PRODUCTION CHANGE and SERVICE BULLETIN

NOVEMBER 1977

MODIFICATION TO MINIMIZE THE FAILURE RATE OF TRANSISTOR Q1
AND INCREASE THE RELIABILITY OF THE VAT-40 VOLT AMP TESTER.

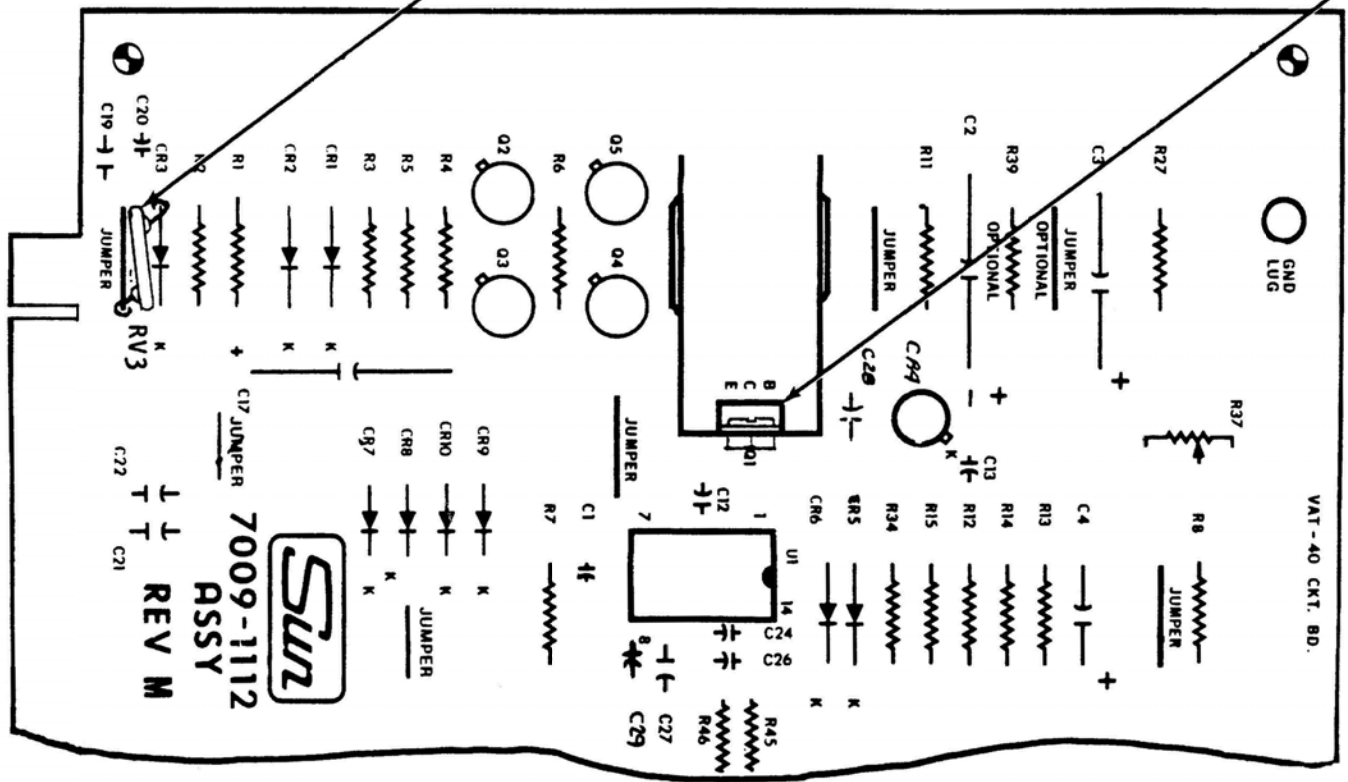
THE 7009-1112 CIRCUIT BOARD USED IN THE VAT-40 VOLT AMP TESTER HAS BEEN MODIFIED TO DECREASE THE FAILURE RATE OF POWER TRANSISTOR Q1 (PASS REGULATOR). TRANSISTOR Q1 HAS BEEN REPLACED WITH ONE THAT HAS TWICE THE EMITTER-COLLECTOR BREAKDOWN VOLTAGE RATING. VARISTOR RV3 HAS BEEN ADDED ACROSS THE POWER INPUT LEADS (PINS A and B) TO SHUNT ANY VOLTAGE TRANSIENTS ABOVE 68 VOLTS.

CHANGE TRANSISTOR Q1 FROM ---- 0776-0233 ---- (2N6109) ---- Vceo 50 VOLTS
TO ---- 0776-0253 ---- (2N6476) ---- Vceo 120 VOLTS

ADD VARISTOR RV3 BETWEEN ANODE OF CR3 AND INBOARD END OF ADJACENT JUMPER
0749-0209 ---- 68 VOLTS @ 1 ma D.C. ---- (GE #V68ZA10)

VAT-40 CIRCUIT BOARD 7009-1112 REV "M" OR LATER WILL INCORPORATE THESE CHANGES.
